Talbot Field Development D/4273/2021, Harbour Energy response to Notice Under Regulation 12(3)

This letter has been prepared in response to the notice received on 17th January 2023 from the Offshore Petroleum Regulator for Environment and Decommissioning (“OPRED”) under section 12(3) of The Offshore Oil and Gas Exploration, Production, Unloading and Storage (Environmental Impact Assessment) Regulations in relation to the Talbot Field Development Environmental Statement.

Figure 1 – Bathymetry of Talbot Appraisal Drill-Site Location

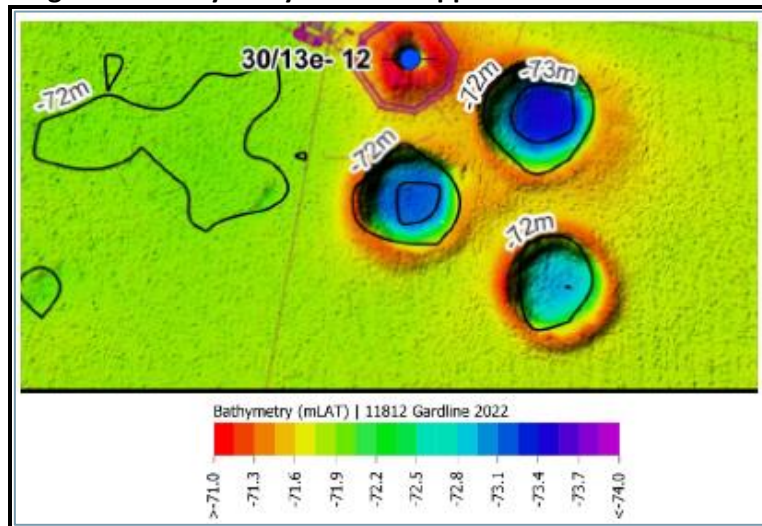
OPRED Comment 6: “Section 3.5.5 – The cuttings transportation system mentioned here should be described in further detail, with information given on its use including the predicted location, nature, scale and extent of the discharged cuttings resulting from its use.”

Therefore, where the cuttings are thick enough to have any potential seabed impacts, they are likely to remain highly localised to the discharge point. Impacts on the MCZ's designated features, specifically the ocean quahog will therefore be insignificant on a population basis given the small area impacted. The Talbot appraisal well was surveyed 60 days after the rig left and this clearly shows

cuttings around the well site to a thickness of approximately 1.3m but very little change in seabed depth immediately (a few metres) from the well site suggesting a very small impact area (no CTS was used in the appraisal well). This Survey visual is included in the figures supporting this response (Figures 1 and 2).
